APPLICATION FOR CERTIFICATE OF APPROPRIATENESS

1315 E Main Street Alteration

RE: Application No. 13-022
1317 E. Main Street

CERTIFICATE OF APPROPRIATENESS

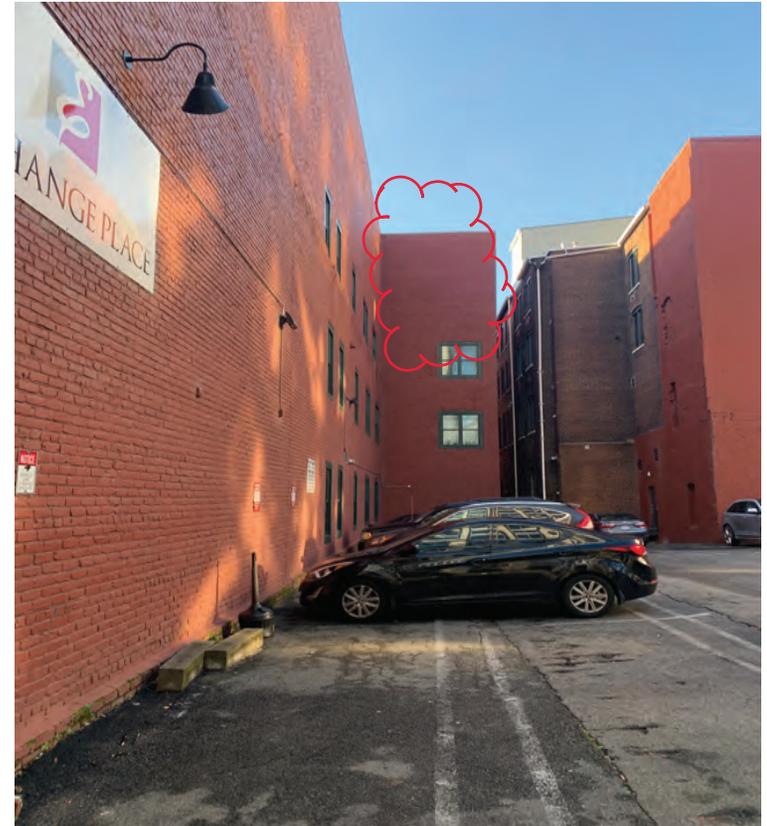
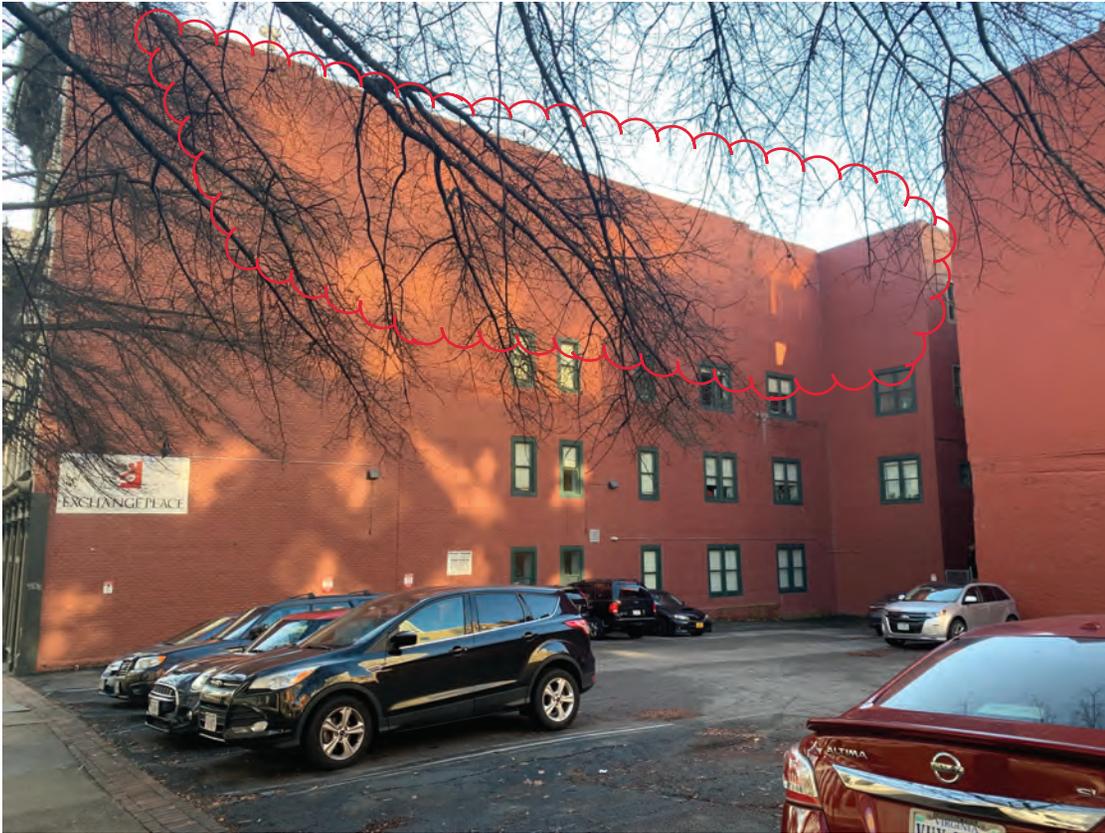
- Along the east and west elevations, as well as the partial north elevation set back from the street, new window openings are proposed as shown on the drawings. These new windows will match the existing modern windows installed during the previous renovation of the building, in size, color, material and operability. These are aluminum single hung windows in a green patina color finish.

- The new windows along the west and east elevation will align with the modern window openings below except for the two single hung windows in the northernmost unit, where it is the only option for natural light in that unit. The previous Certificate of Occupancy notes that windows should be continued to the fourth floor.

- Along the east and south elevations there are two existing balcony spaces whose exterior walls create a triangular shape exterior space. The applicant proposes to remove those angled walls and install an exterior wall parallel to the railing with new full-light patio doors as shown.

SOUTH ELEVATION_4TH FLOOR ATRIUM NOT VISIBLE

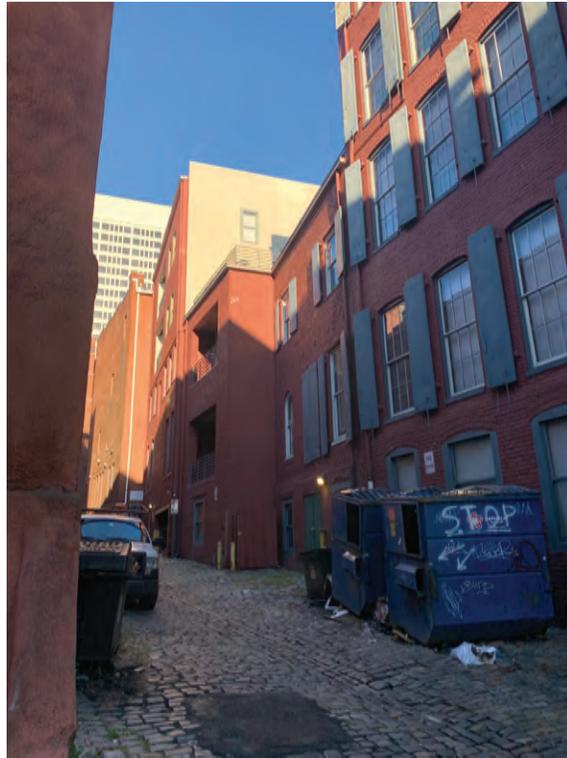
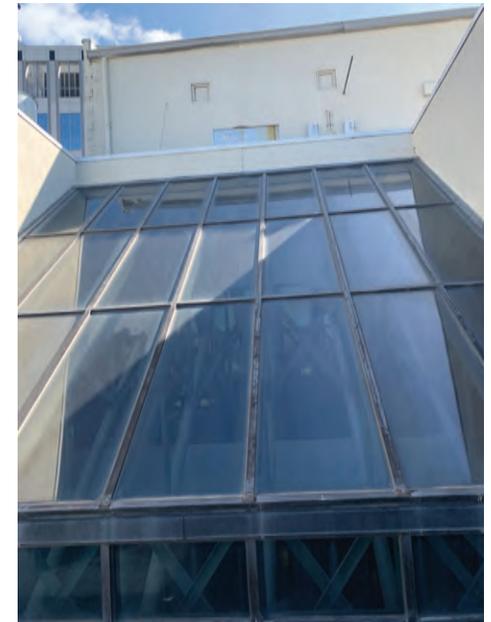
- The south elevation has a large modern glass storefront atrium. Applicant proposes to remove the atrium, infill the floor and build-out onto the exterior patio as shown on the drawings. This will not be visible from the surrounding area and the new wall will be held back from the historic rear elevation and patio space will be provided for three units. The wall will be constructed of studs and clad in Sto EIFS. Finish and color will match the surrounding stucco.

STOREFRONT TO BE REMOVED AND BUILT-OUT
NEW EXTERIOR EIFS FINISH TO MATCH SURROUNDING

ATRIUM STRUCTURE TO BE REMOVED

4TH FLOOR ATRIUM TO BE REMOVED
